MADISON PARK MULTIFAMILY

MASTER USE PERMIT
DESIGN RECOMMENDATION PACKAGE -
ADMINISTRATIVE DESIGN REVIEW

SEATTLE DCI PROJECT #: 3038537-LU (3024825-EG)
06/30/22

EDG ITEMIZED RESPONSE

Rendered Image of entry stair

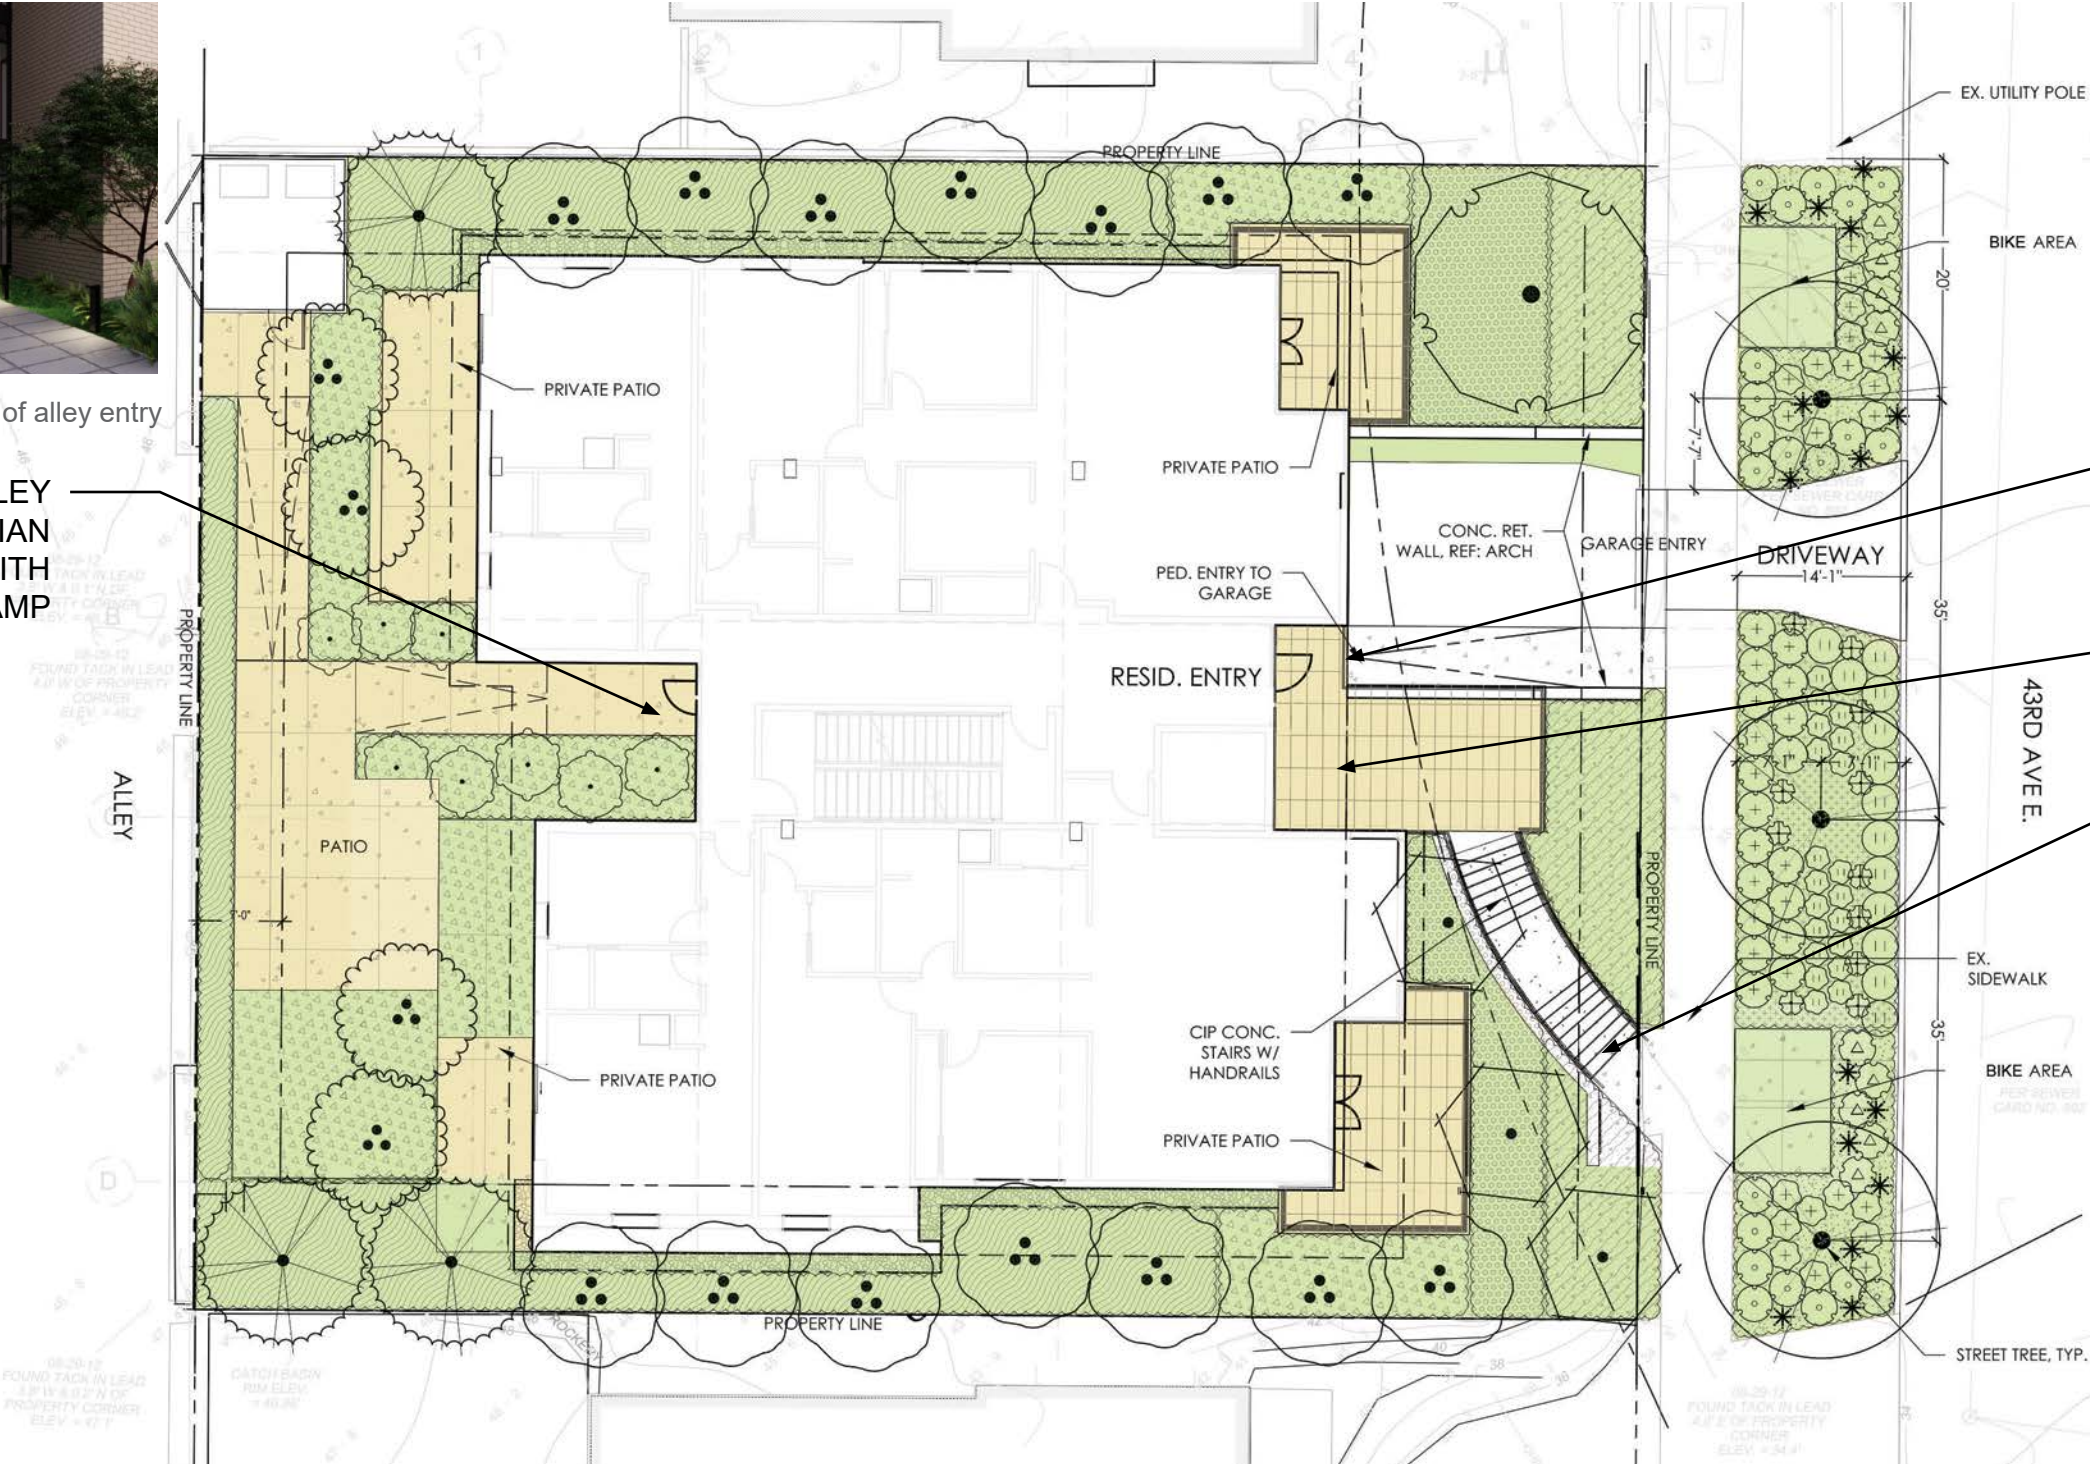
A. Staff generally supports the location of the primary residential entry along 43rd Ave S but is concerned that the large number of steps associated with the long curvilinear stair bifurcates land area that could be used as public and private amenity space and provide a greater connection to the street. Modify this aspect of the design to resolve these concerns. (PL2-A, PL2-B, PL2-D-1, PL3-A-4, PL3-A-1, PL3-C-2, PL4-A)

Studies were performed for alternative solutions of the entry stair. A switchback type stair was reviewed and it was determined too visually intrusive from the public street, with the need for guardrails doubling up resulting in a stair mass that takes up a larger footprint both visually and in plan than a single curvilinear stair provided. The proposed curved stair recalls the existing site access curved stair and provides a minimal visual weight while allowing for an elegant, natural curved access path for pedestrian comfort. At the public street, there is a recessed landing area at the foot of the stairs at the public realm, where one can sit and rest. The terrace off the main entry is a semi-public space where visitors and residents can take in the

elevated views of the lake, gather, and connect with street life. Refer to page 34 for rendered image of entry stair.

Documentation for SMC 23.45.536.C.2.b.2

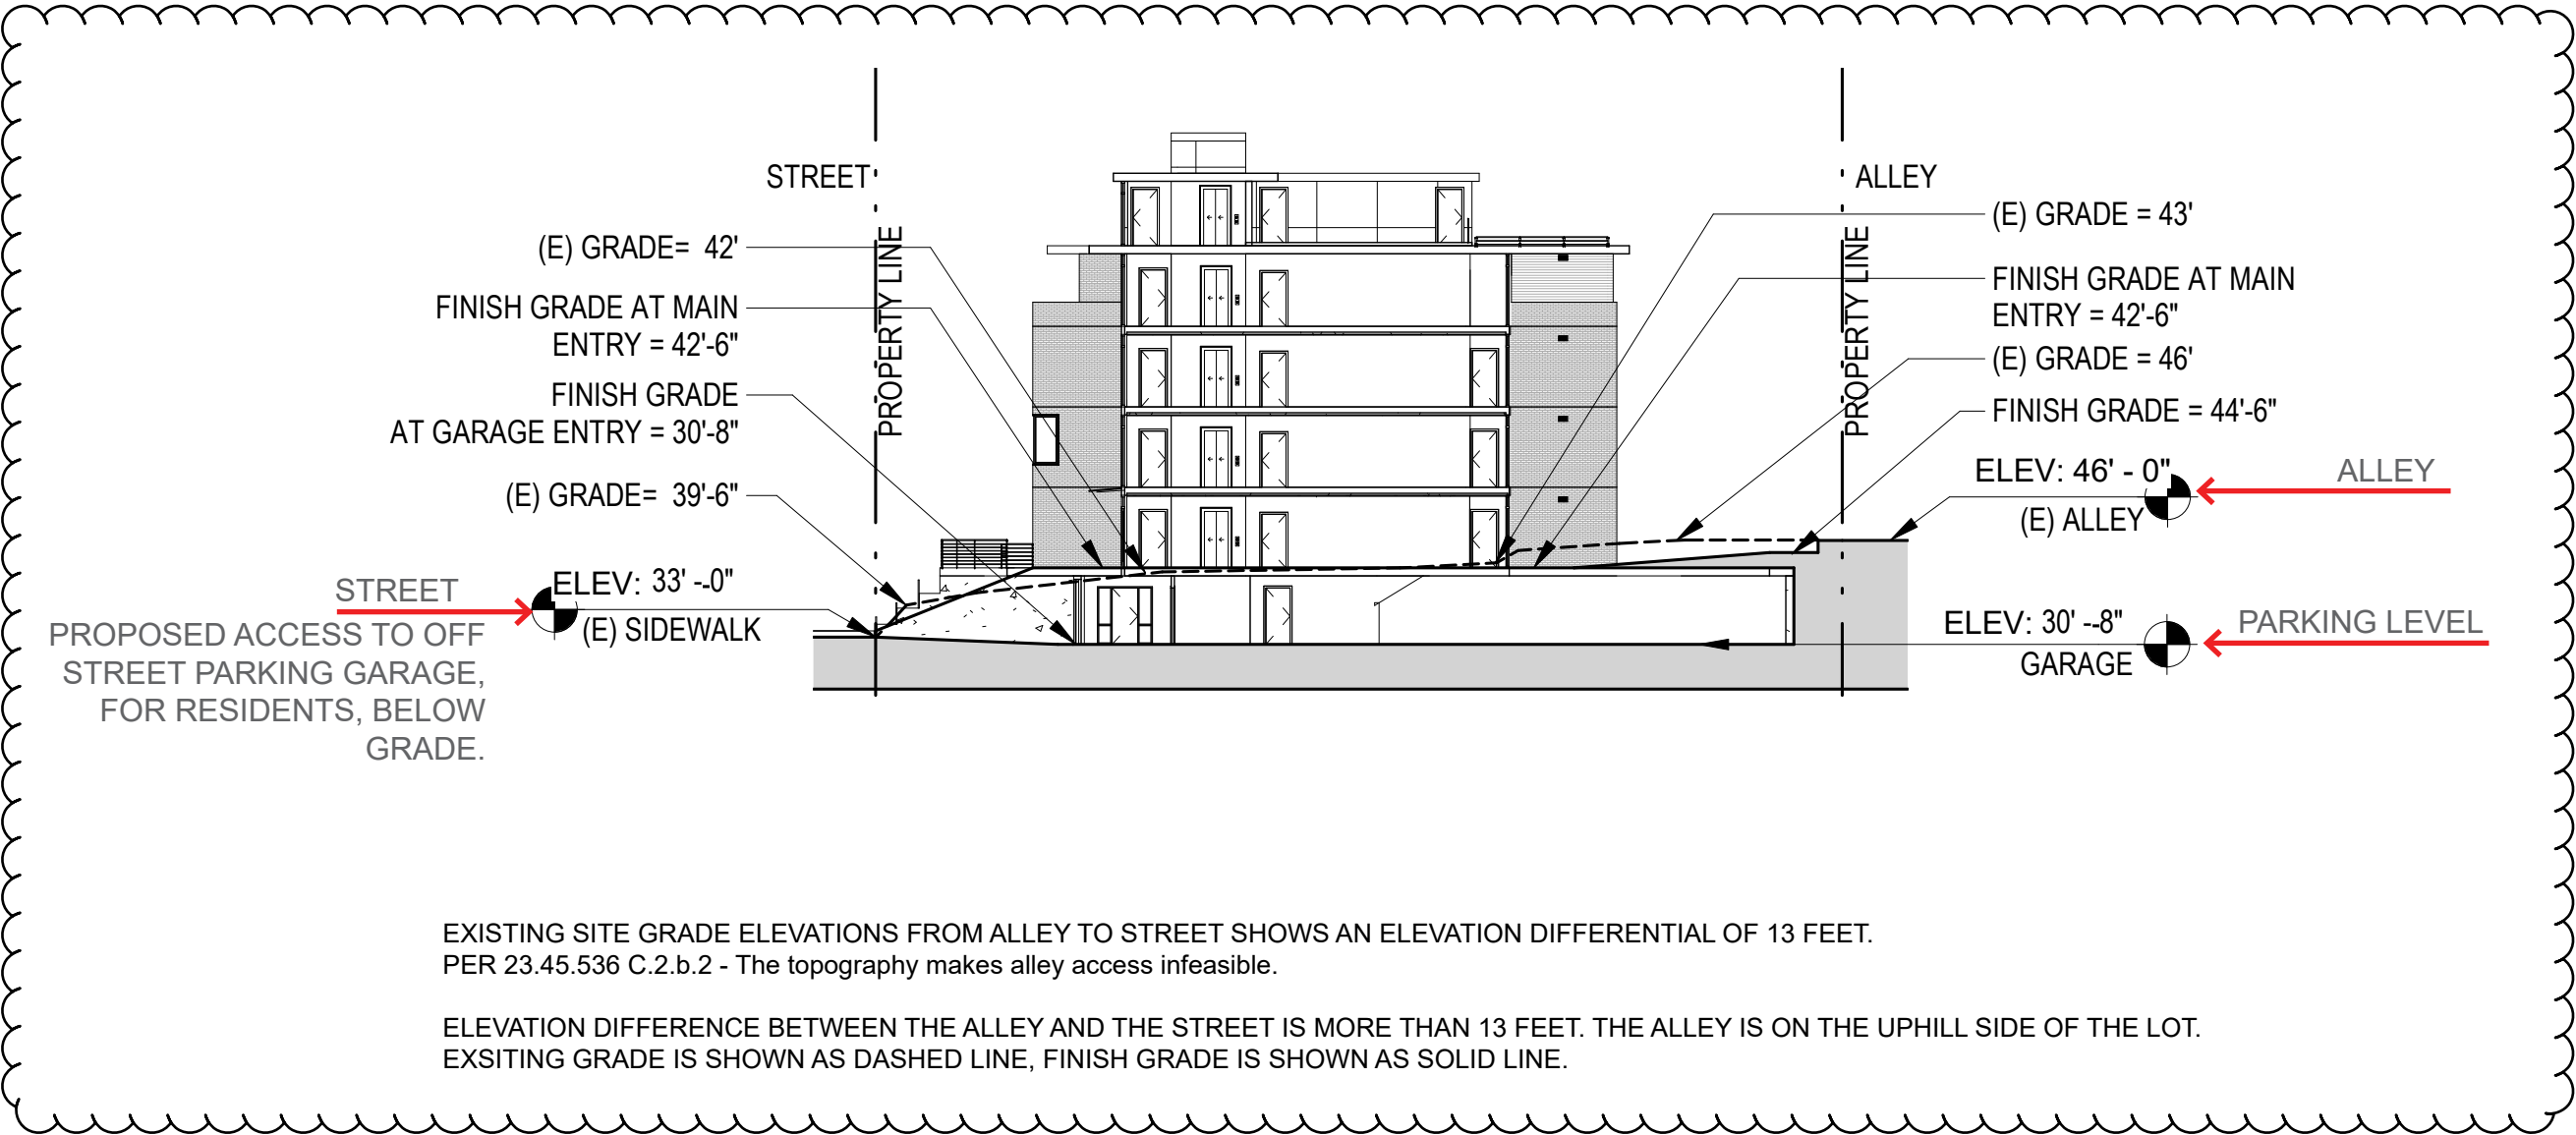
A. In agreement with the First EDG, Staff continues to question why the driveway cannot come directly off the alley and into the underground parking and why a departure for driveway slope is not being pursued. (PL4-A-1, PL4-B-2, PL4-B-2, PL4B-3)

A driveway with a slope departure was reviewed by the civil engineer as directed by the Zoning Reviewer. A direct and straight driveway into the garage resulted in a 66% slope to provide for the needed elevation change to access the below grade parking. This slope percent is not recommended and will not be designed by the civil engineer, refer to page 30-31 for diagrams of driveway alternatives and appendix A for engineer's report and recommendations.

Per SMC 23.45.536 C.2.B.2, this site meets requirements to allow access off the street due to topography. The existing elevation difference from street to alley, is approximately 15 feet (refer to page 27 for the site section). This elevation difference results in a driveway slope well exceeding the code required 15% in order to maintain the required parking and desired pedestrian scale and experience. Our team is proposing Director's Ruling on providing parking access from the street. Our civil engineer officially recommends the preferred Alternative A design, and this design has been approved by Zoning thru the MUP review process.

Current Design with Parking Access off Street

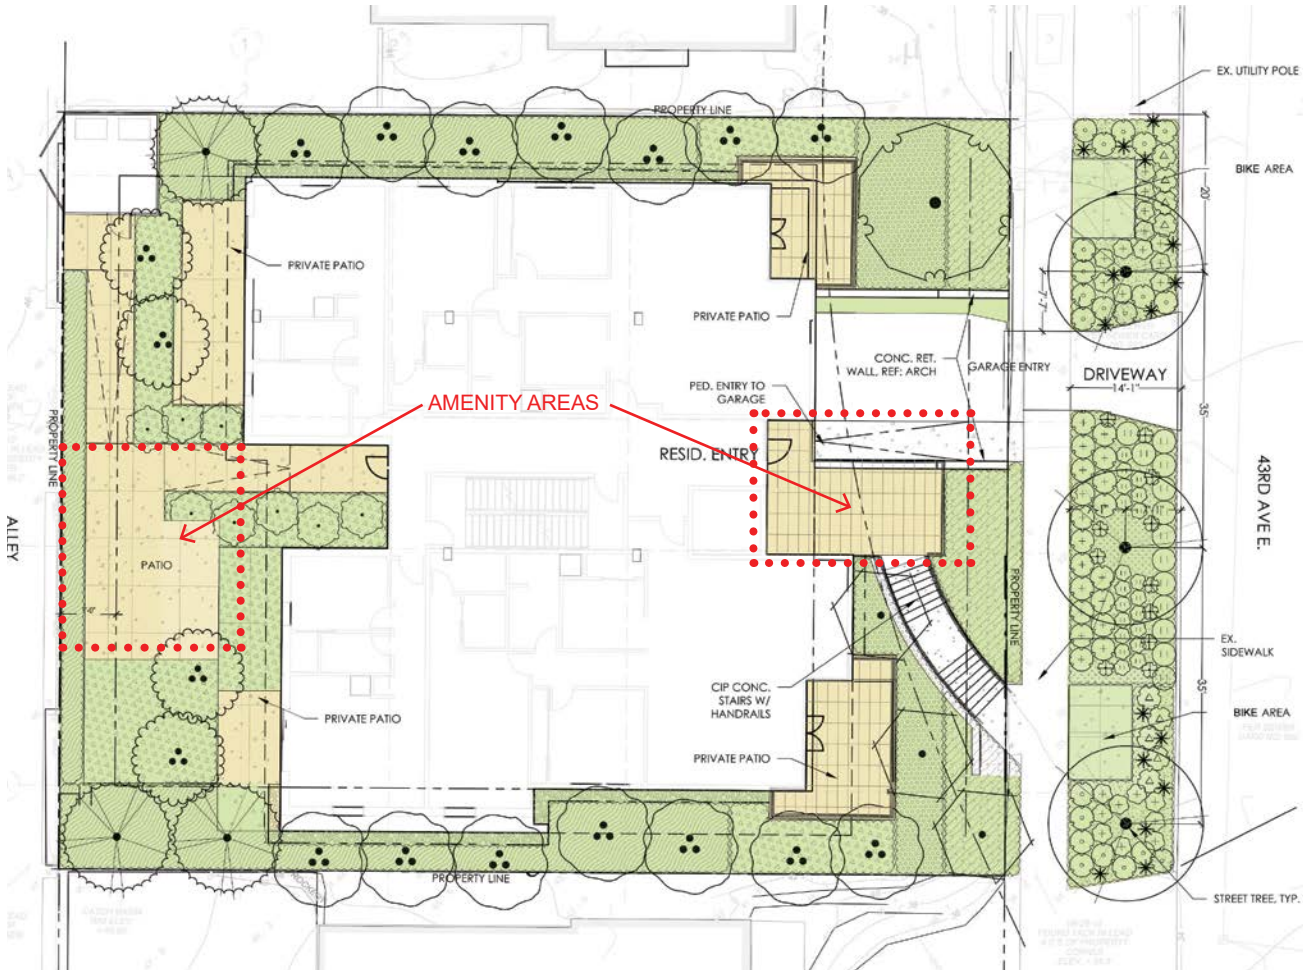
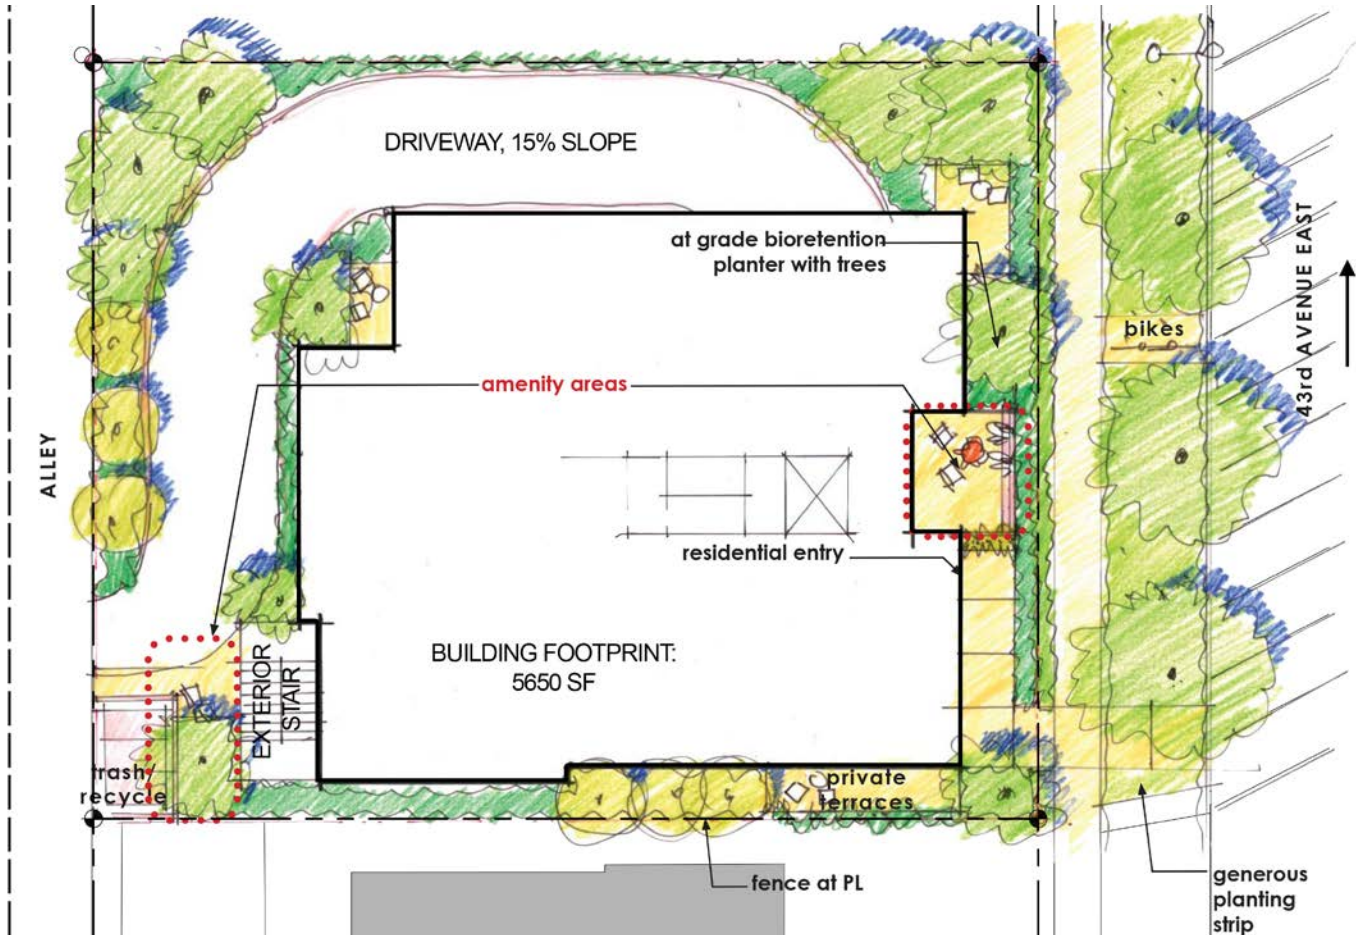
A. The description in the EDG packet indicates that the driveway off 43rd Ave E maximizes green factor. The design team shall demonstrate graphically how this will be accomplished. (PL4-A, PL4-B, DC1-C)

We have provided diagrams and green factor worksheets comparing the parking access from the street vs. the alley. Parking access from street will provide the best opportunity to maximize Green Factor. Providing parking access from the alley would not meet green factor code according to calculations provided. See site plan analysis and worksheets on page 28 & 29. After reviews completed by MUP Zoning team, Green Factor was not relevant to the decision of driveway access.

4440 sf of green space (38% of lot)
 1858 sf of hardscape (16% of lot)
 706 sf of terrace/patio amenity space (6% of lot)
 5005 sf of building footprint (43% of lot)

GREEN FACTOR SCORE STREET ACCESS: 0.624

Alternative Design with Parking Access off Alley

3960 sf of green space (34% of lot)
 2812 sf of hardscape (24% of lot)
 442 sf of terrace/patio amenity space (4% of lot)
 4830 sf of building footprint (41% of lot)

GREEN FACTOR SCORE ALLEY ACCESS: 0.571
